Julia May, Environmental Consultant
3122 College Ave., Berkeley, CA 94705
jmay@sbcglobal.net, 510/658-2591

August 29, 2006

**Re: Comments on DEIS for Mandan, Hidatsa and Arikara Nation's
Proposed Clean Fuels Refinery Project**

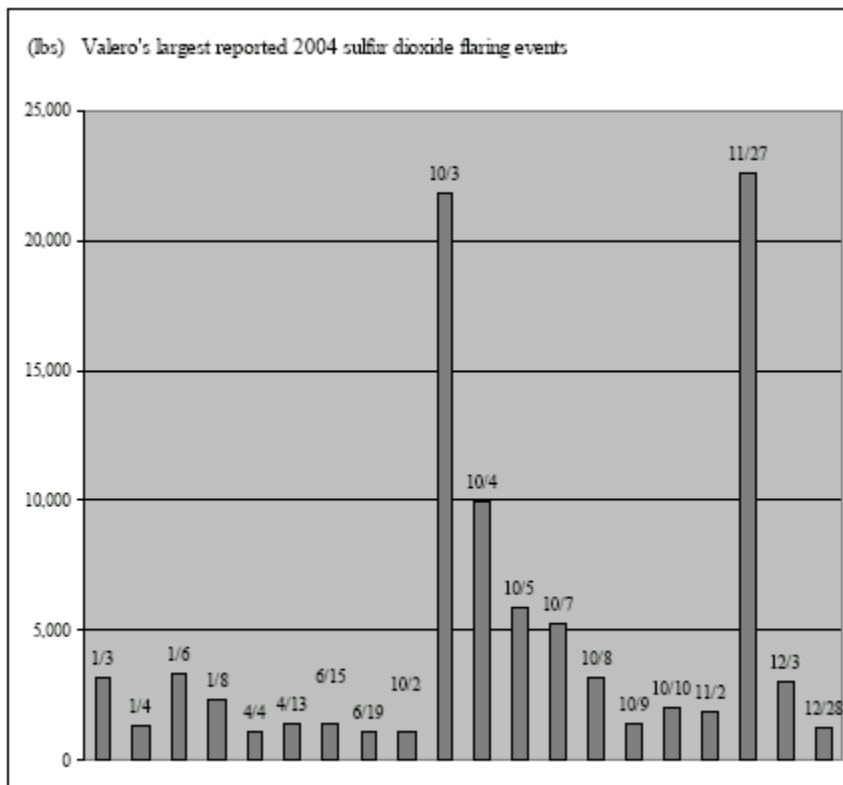
Tesoro in Avon had 36 flaring events that generated more than 5,000 lbs. of sulfur dioxide each.

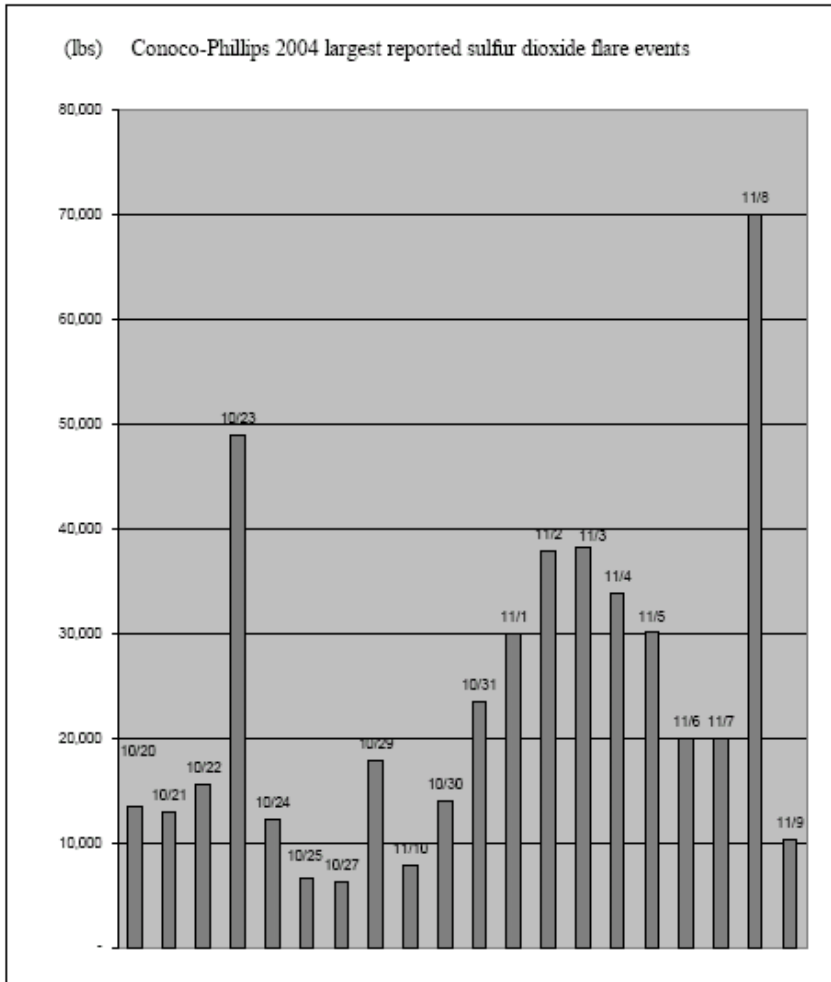
Valero in Benicia reported 20 flaring events with sulfur dioxide emissions of more than 1,000 lbs. each (plus dozens of additional smaller events).
